Service Bulletin 70

Vertical fin cracks

All Sportsman aircraft

Inspection of the vertical fin and aft fuselage bulkheads B and C, repair of vertical fin and bulkheads and reinforcement of vertical fin spar attach to bulkhead C.

Required Action:

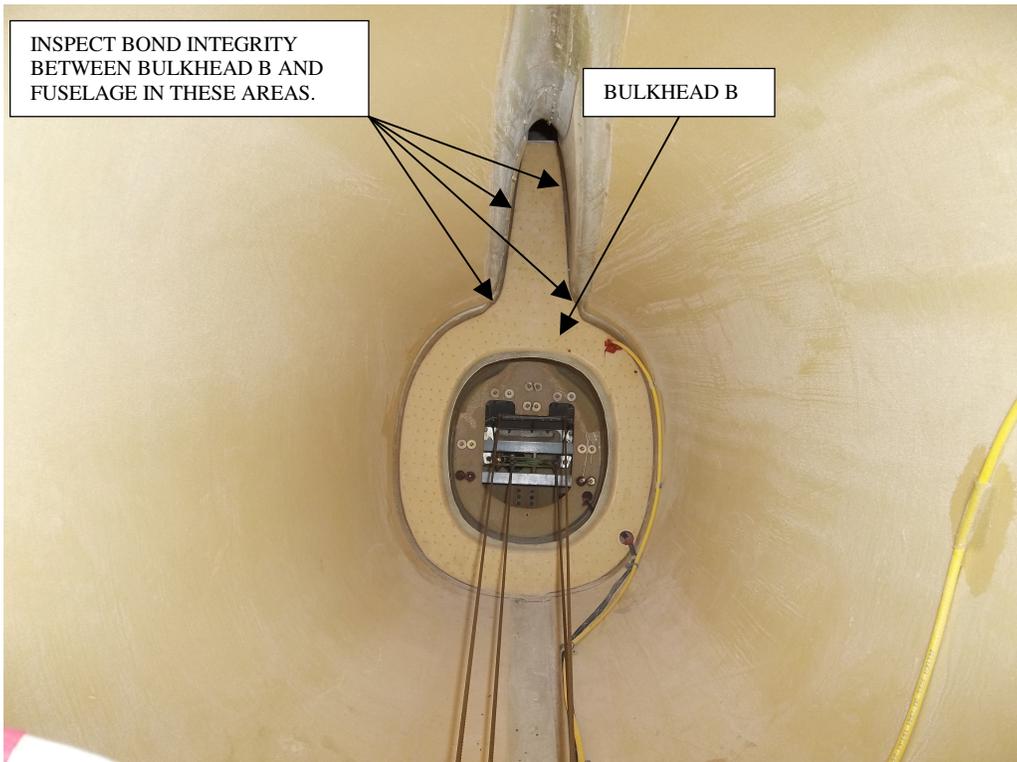
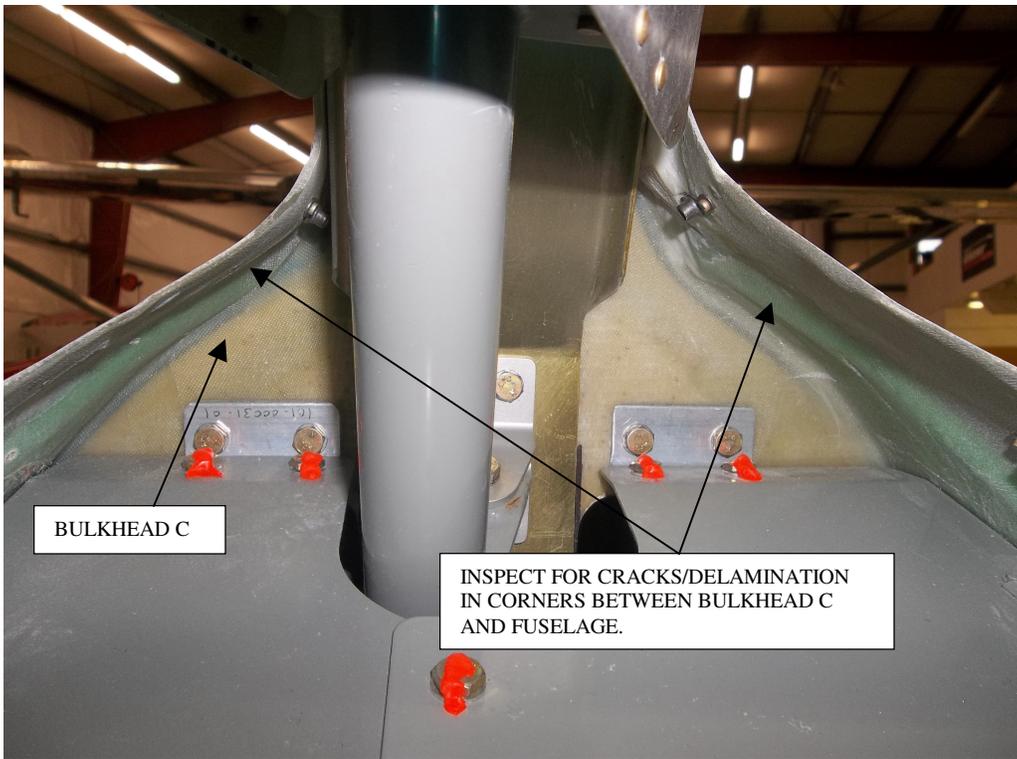
- 1) An inspection is to be completed prior to the next flight.
- 2) Repairs to interior cracks and separation are to be completed as outlined below prior to the next flight.
- 3) Reinforcement of the attachment of the vertical fin spar to bulkhead C with part # 101-00019-01 should be completed after all composite repairs are accomplished. Installation should be completed prior to or during the next annual inspection.

Note: we found that while repairs to the existing structure are important, the reinforcement doubler by far is the most significant component to prevent future cracking issues in this area.

REPAIRS:

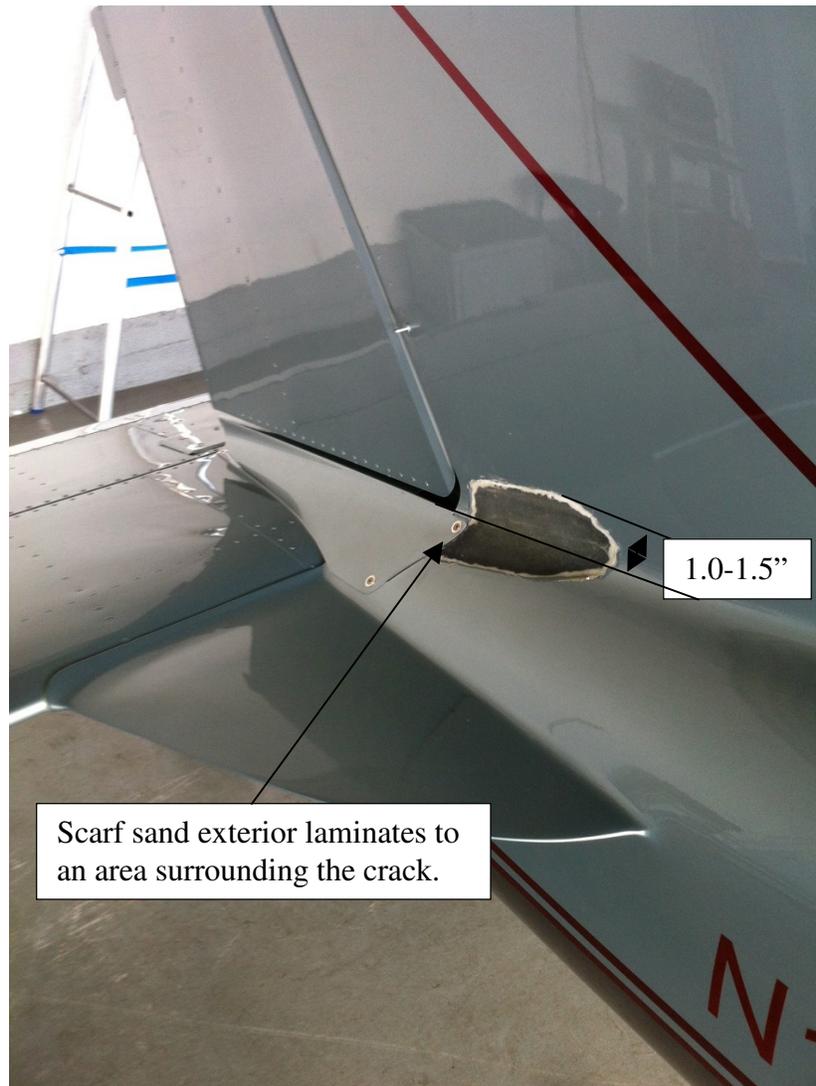
External cracks: Sand through the paint and filler in the areas of external cracks to determine if the cracks are deep enough to be in the laminates. If so, scarf (taper) sand the external laminates down to a level where the cracks disappear (do not exceed a depth of 1/16" deep). The tapered-sanded area should extend approximately 1.0-1.5" beyond the crack. Cut some plies of 7781 fiberglass cloth on a 45 degree bias to fill the area sanded. You will need to use 2 or 3 plies depending on the depth of your scarf joint at the deepest point. The pieces of cloth will need to increase in size from approximately 1.0" wide to 2.0" wide so that the edges do not stack directly on top of each other.

Clean the area with acetone and laminate the cloth layers in place followed by a piece of peel ply. (Do not add extra resin with the peel ply. Wipe any excess resin from the brush and allow

FILE NO. 00019-01 LOCATION 101	DRAWN BY: KEVR APPROVAL DATE: 02/19/13 DATE: SIZE A	SCALE: NONE DWG NO. 101-00019 USED ON: SHT. 1 of 2

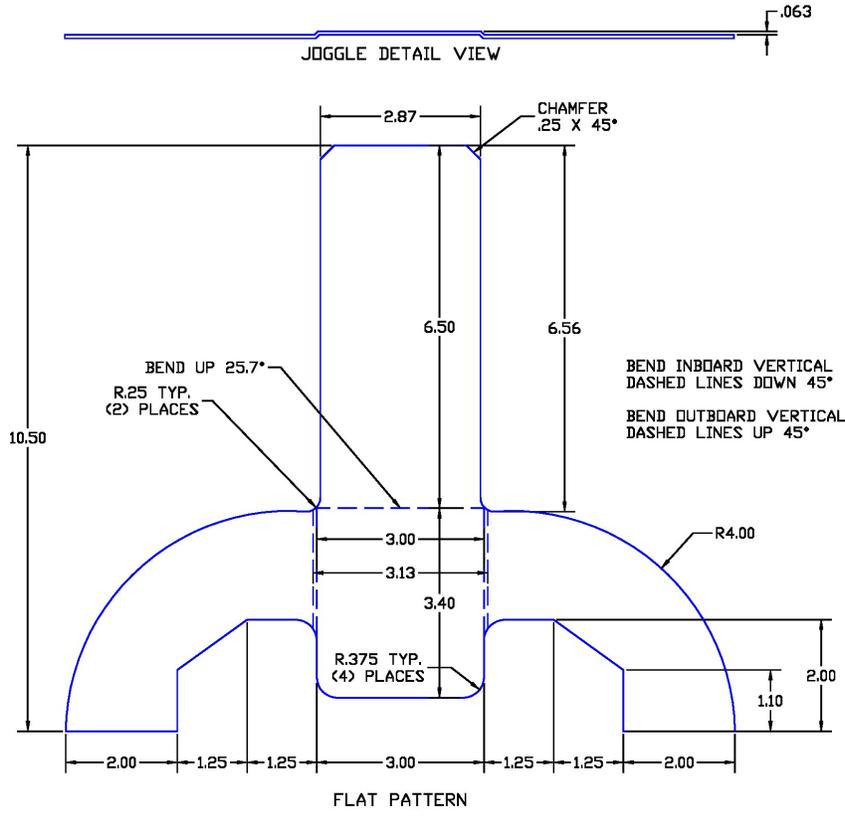
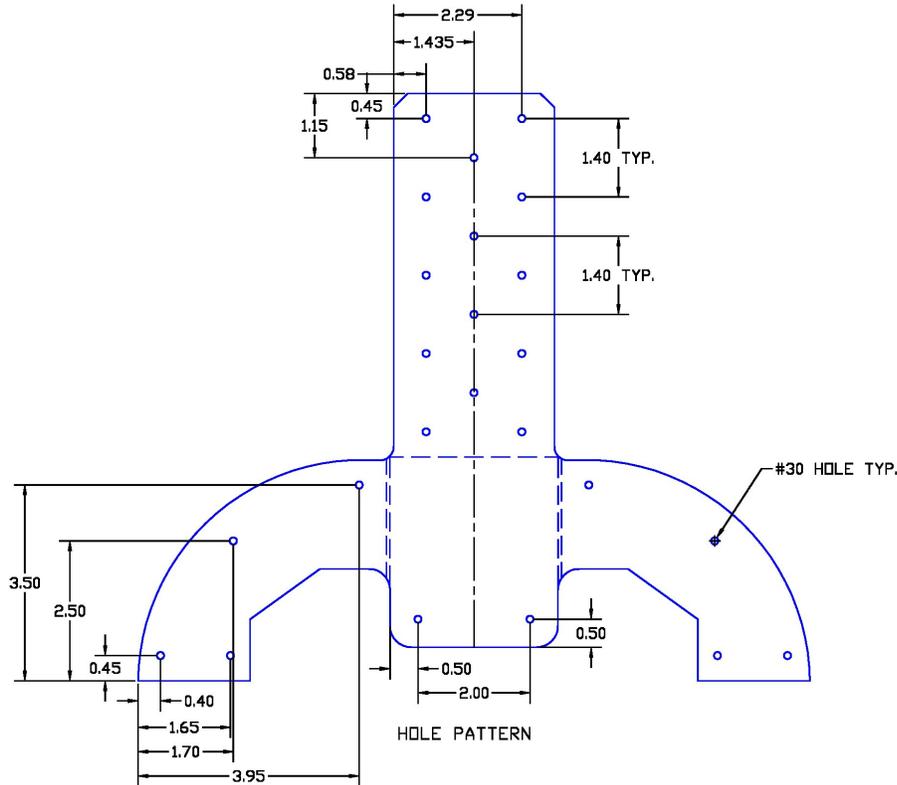
To add an extra degree of stiffness to the attachment of the vertical fin spar to bulkhead C for prevention of future cracking, an aluminum doubler (shaped like an inverted sling-shot) is placed beneath the lower rudder hinge flush against the spar and bulkhead. It is fastened with AAPQ-42 pull rivets to the vertical fin spar. It uses the four AN-3 rudder hinge bolts and forward shearweb bracket bolts to tie the doubler to bulkhead C as well as additional AAPQ-42 rivets. A part drawing has been included for reference, should you wish to fabricate the part yourself. The part will also be available for purchase from Glasair Aviation; contact customer service by phone (360-435-8533 EXT. 232) or email (harry.delong@glasairaviation.com) for details.

The result of adding the .063” thick doubler beneath the hinge and brackets will be to shift the rudder and shearweb brackets back by 1/16”. Simply file the holes in the forward shearweb oblong by this amount to accommodate alignment of the bolts to the nutplates.
